**BELL BEND NUCLEAR POWER PLANT  
RESPONSE TO ENVIRONMENTAL  
REQUESTS FOR ADDITIONAL  
INFORMATION, SIXTH SUBMITTAL  
BNP-2009-313      Docket No. 52-039**

Responses to Environmental Requests for Additional Information  
Bell Bend Nuclear Power Plant  
Luzerne County Pennsylvania

**Figure 2.4-3 Location of the Onsite Ponds and Aquatic Biota Collection Stations in Walker Run**

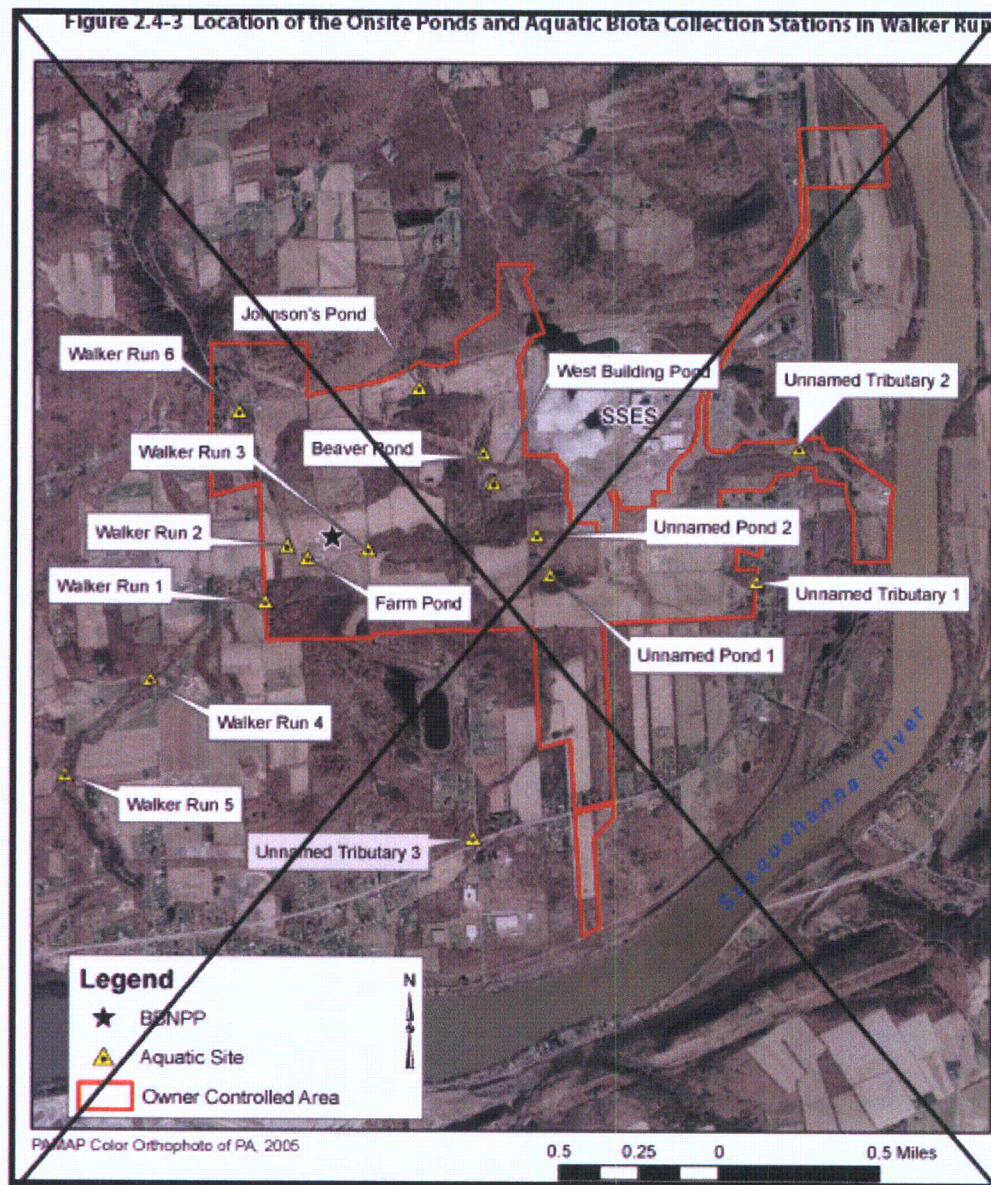
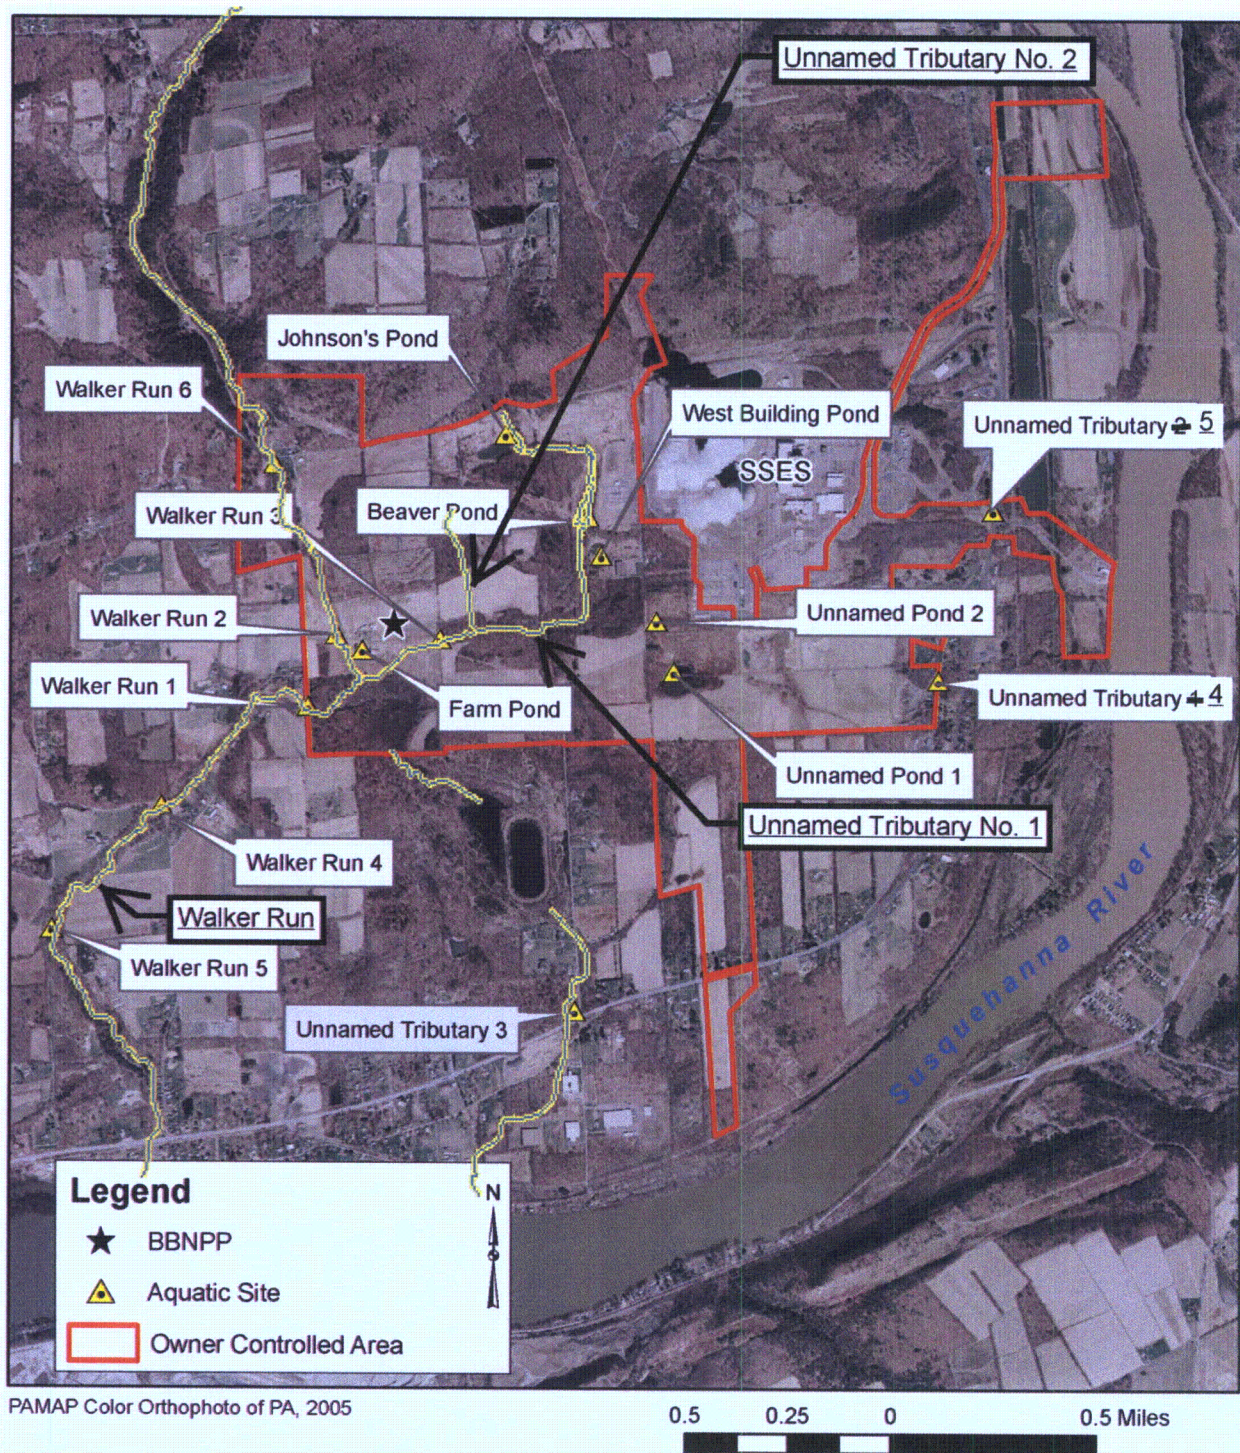
- ER Figure 2.4-3 (in the COLA Impact section) has been marked to illustrate proposed changes to the Figure. The proposed changes clarify the location of streams and ponds discussed in ER Section 2.3.1.

Waterbodies at the BBNPP site are described in Section 2.3.1. The locations of the on-site surface water biological monitoring locations are provided in Figure 2.4-3. Summary descriptions of the on-site waterbodies' hydrological and physicochemical characteristics are given in Section 2.3.1. Locations of the on-site waterbody aquatic biota sampling locations are shown in Figure 2.4-3. Several of the biological monitoring stations are in close proximity to the surface water monitoring stations described in Section 2.3.1. The following indicates the biological monitoring station name and the corresponding surface monitoring station

**Figure 3.4-6 View of Discharge Outfall for Discharge System for BBNPP**

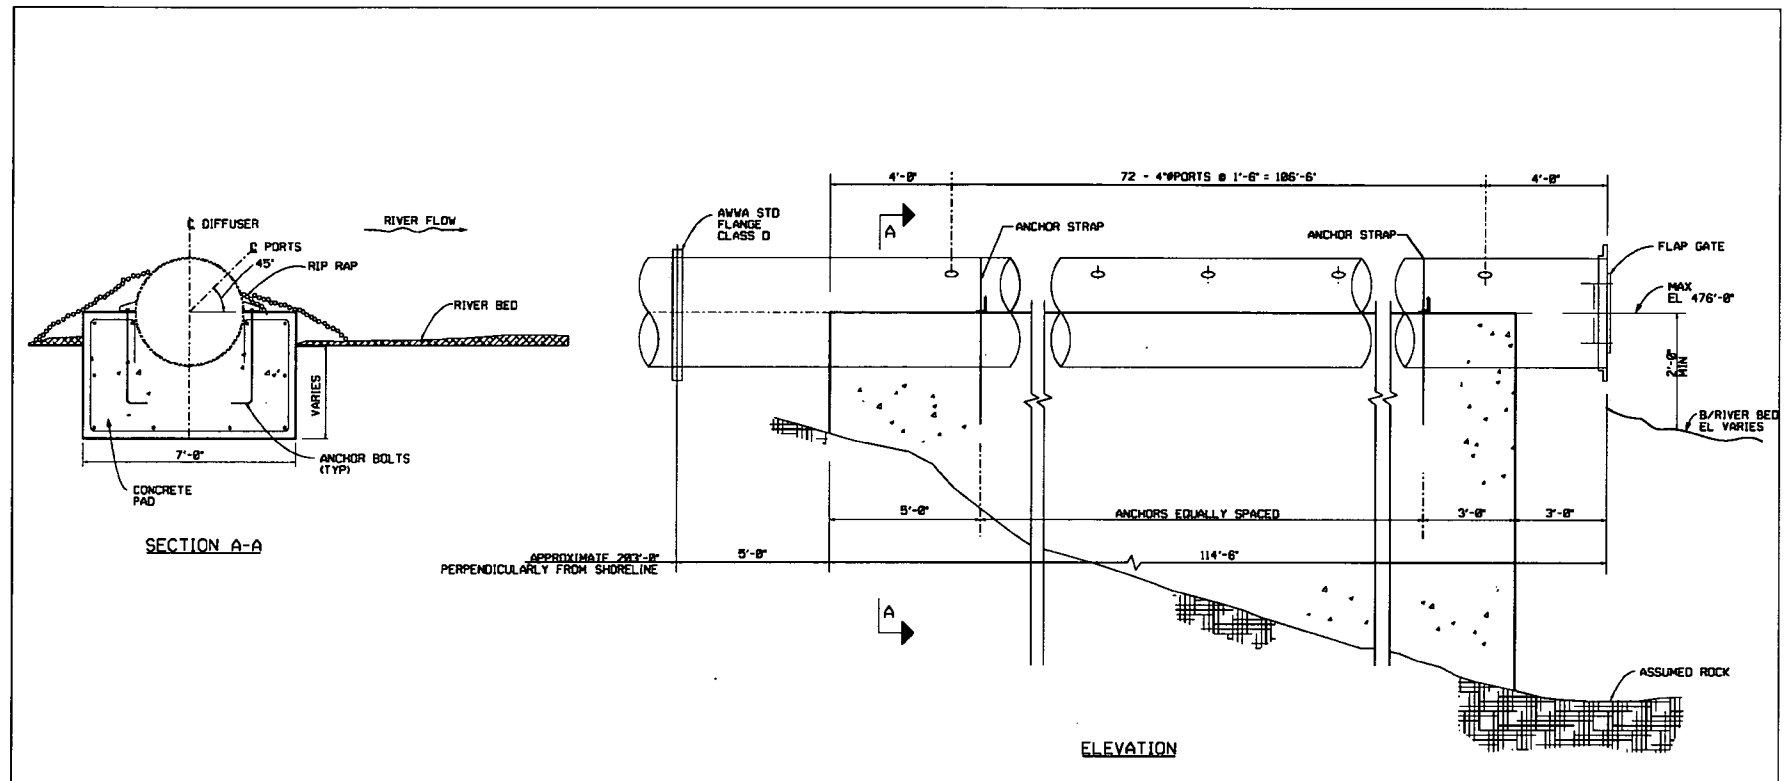
Fourth Bullet: ER Rev 1 p. 29 states that 0.7 ac in the Susquehanna River would be disturbed. This seems to conflict with Table 4.1-1 that lists the total area impacted as 0.7 ac, including forest and wetlands; and the calculations of disturbed area in Section 4.3.2.2 (ER Rev 1, p. 4-45). Please clarify.

The discharge pipe will be slightly below the river bottom and the diffuser is situated at the bottom of the river as shown in Figure 3.4-6. Since the pipe elevation is above the elevation of the rock, no rock excavation will be necessary for the discharge pipeline and diffuser within the river limits.

The excavation for the installation of the discharge pipe and diffuser encompasses an area of approximately 377.5 ft (115.1 m) by 50 ft (15.2 m) wide in the Susquehanna River. This is an area of approximately 18,875 ft<sup>2</sup> (1,753.5 m<sup>2</sup>). The discharge pipeline is supported within the river bottom sand and gravel. The concrete anchor pad for the diffuser is founded on top of the underlying bedrock as shown on Figure 3.4-6. Considering an average depth of excavation of

Figure 1 Locations of Groundwater Monitoring Wells

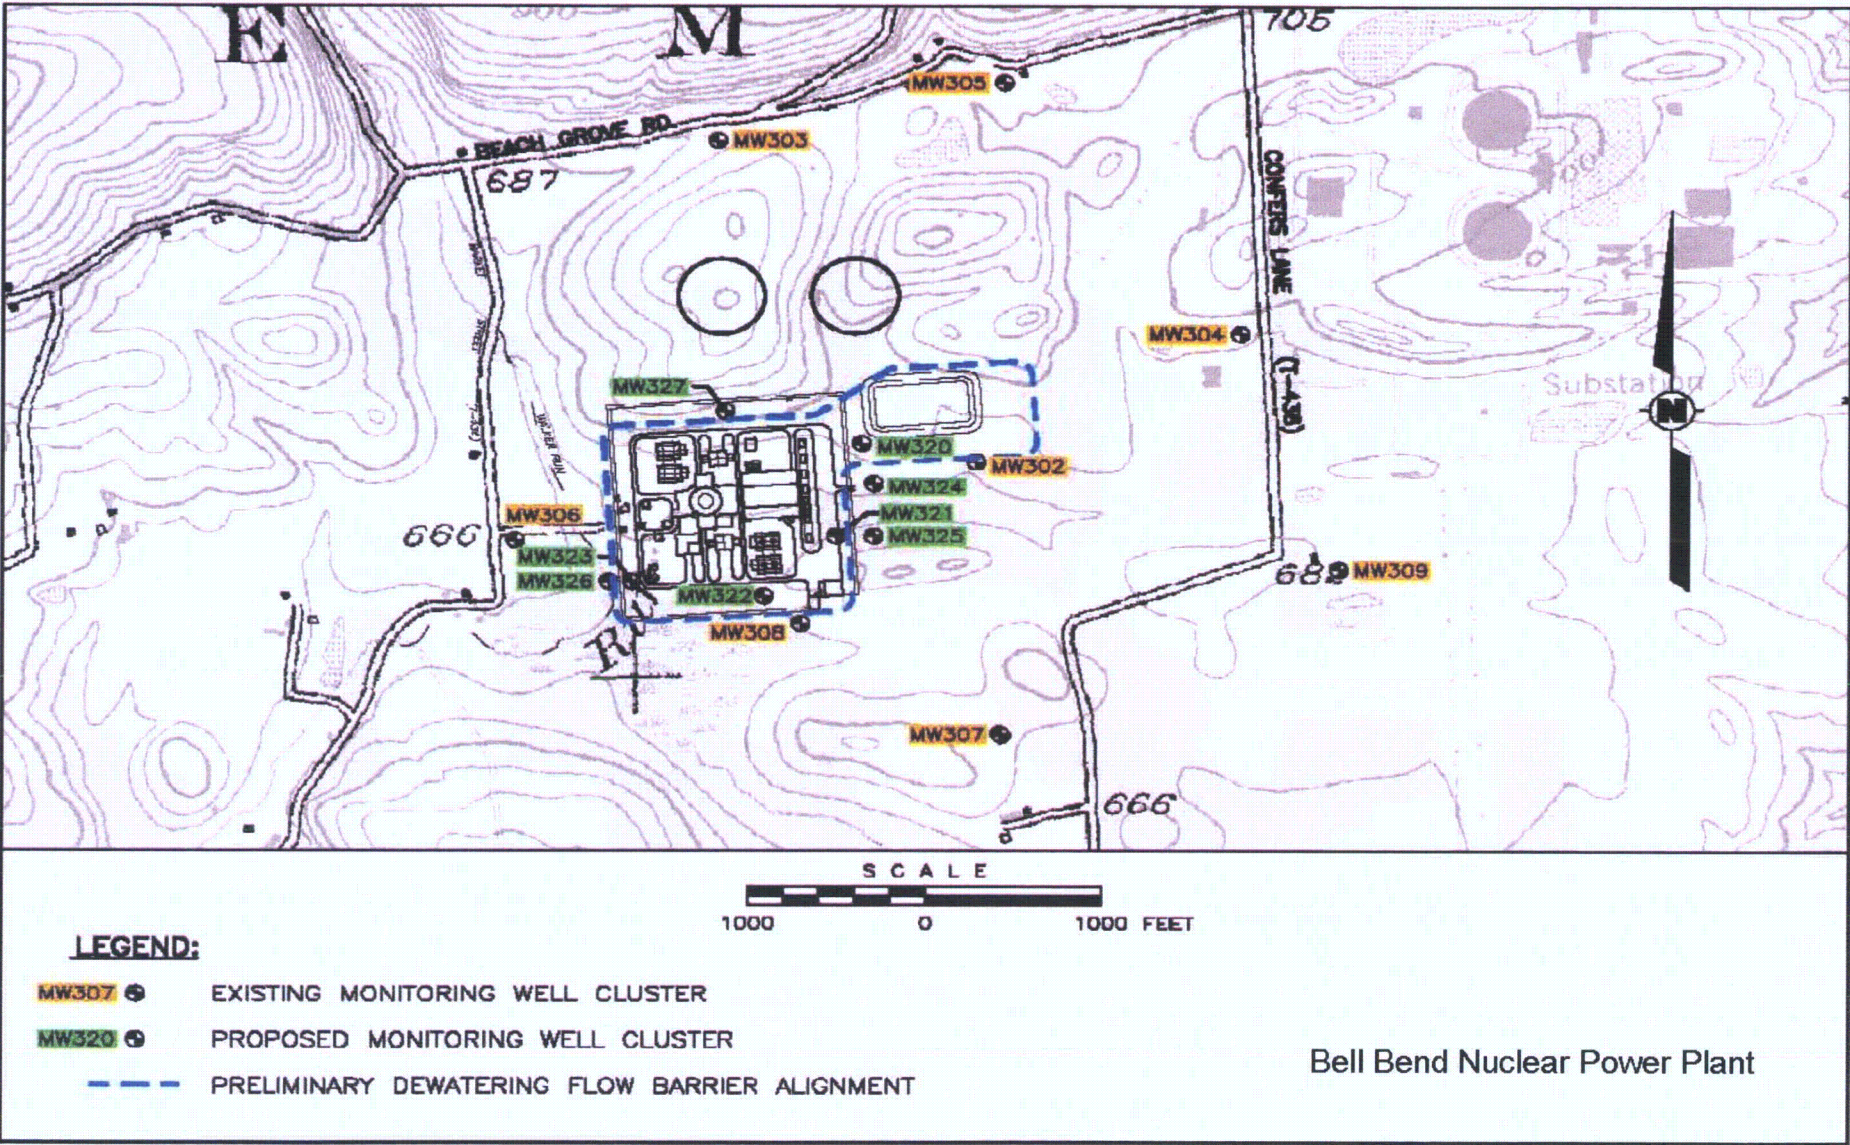
**Summary:** *Provide descriptions of surface water and groundwater monitoring equipment, data collected, measurement schedule, analysis procedures, and data quality objectives for the preapplication, construction, preoperational and operational periods.*

Future groundwater monitoring will be performed using a combination of existing monitoring wells (used for Preapplication site characterization) and proposed new wells installed prior to or during construction, including monitoring for control of any dewatering efforts. Attached Figure 1 shows the locations of eight monitoring wells expected to be left in place (MW-302 through -309) and monitored during construction and eight proposed additional wells (MW-320 through -327). Specifications for existing wells are listed in ER Table 2.3-18. Anticipated specifications for proposed monitoring wells MW-320 through-327 which would be installed prior to or during construction, are provided in attached Table 1. The proposed configuration of monitoring wells during construction may be revised depending on any additional Preapplication data collection efforts, on construction activities, and the final layout of any groundwater flow barrier which is part of the current conceptual dewatering plan, as shown on attached Figure 1. Monitoring equipment includes electronic depth probes, to provide water depths and a YSI Model 6 Series Multi-Probe Meter or equivalent to field-measure pH, temperature, specific conductance, dissolved oxygen, ORP, and turbidity. Monitoring and measurements will be done on a quarterly basis.

Figure 2.1-5 Area Uses During Construction

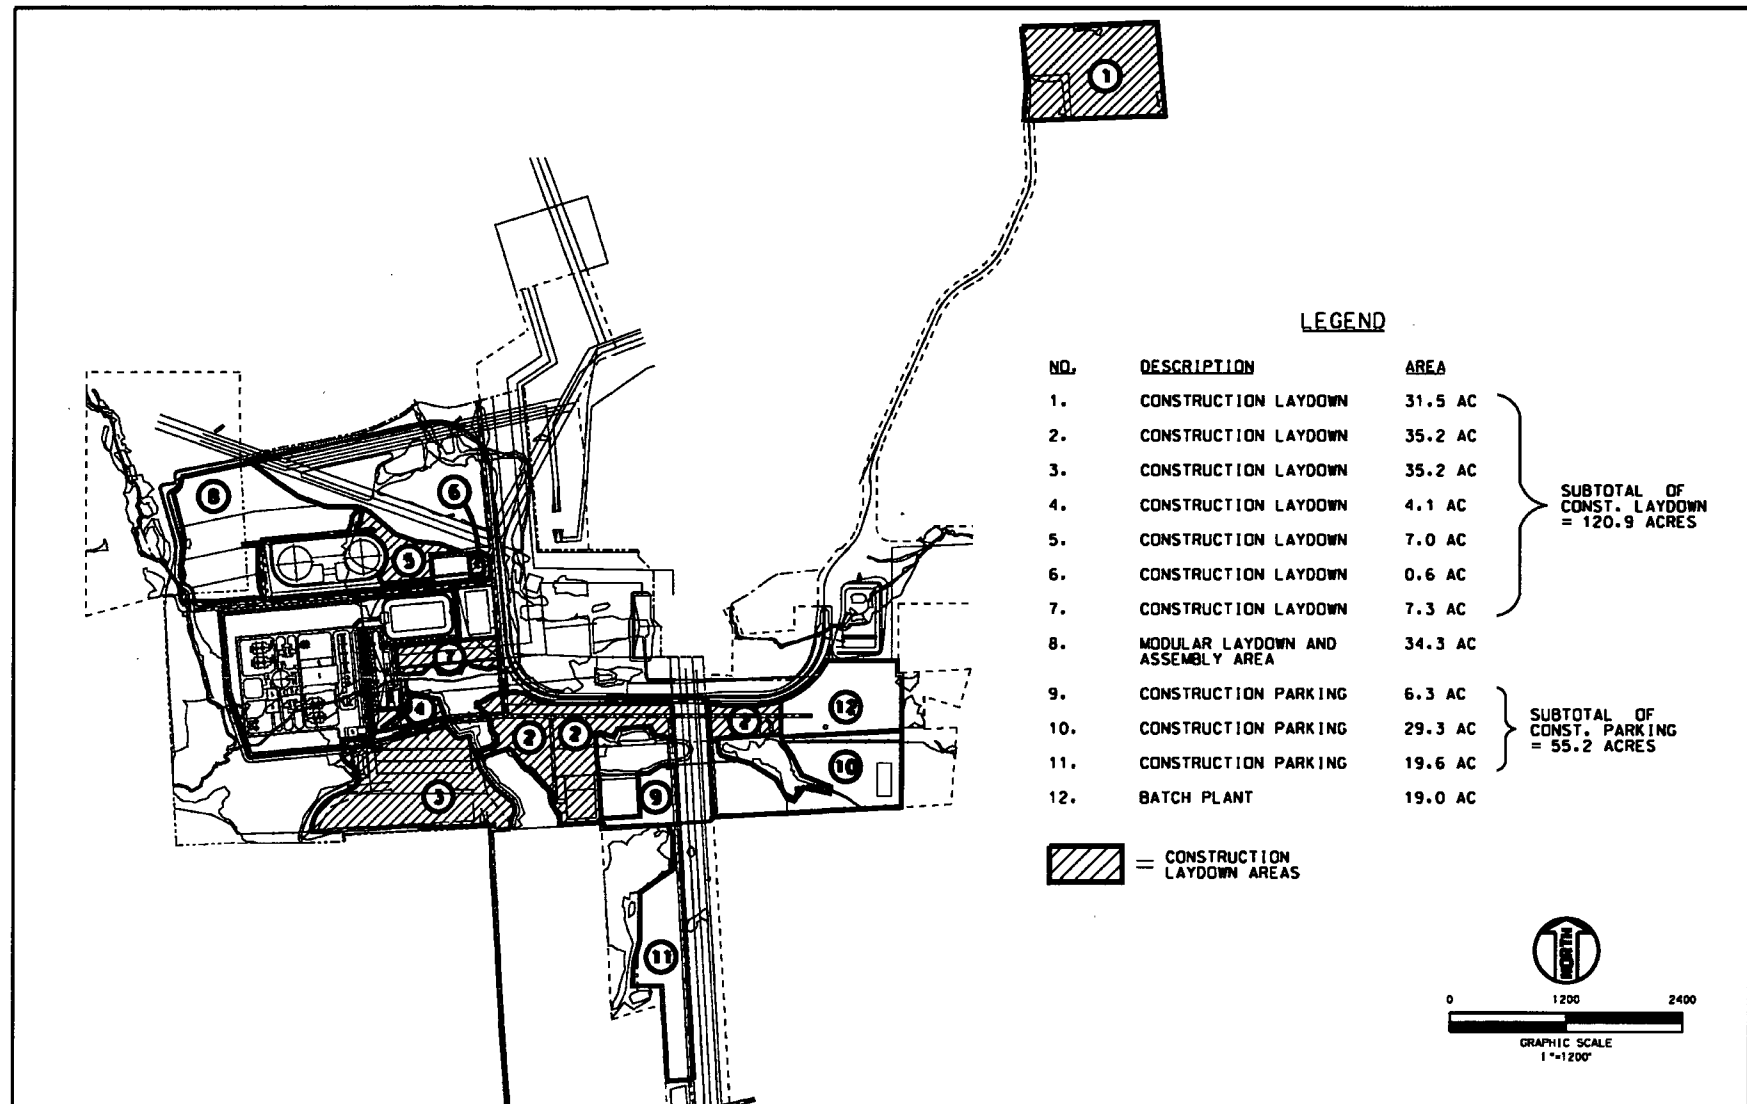
**Summary:** *Identify the location of all lay-down areas in Figure 2.1-1, "BBNPP Site and Proposed New Plant Layout", or provide a new figure to show the location of these features.*

**Response:** The response to this RAI was provided to the NRC in Bell Bend letter BNP-2009-217, dated August 10, 2009. In a recent teleconference, the NRC indicated that the legend for ER Figure 2.1-5, "Area Uses During Construction" was difficult to read. PPL has increased the size of the legend in order to improve legibility.
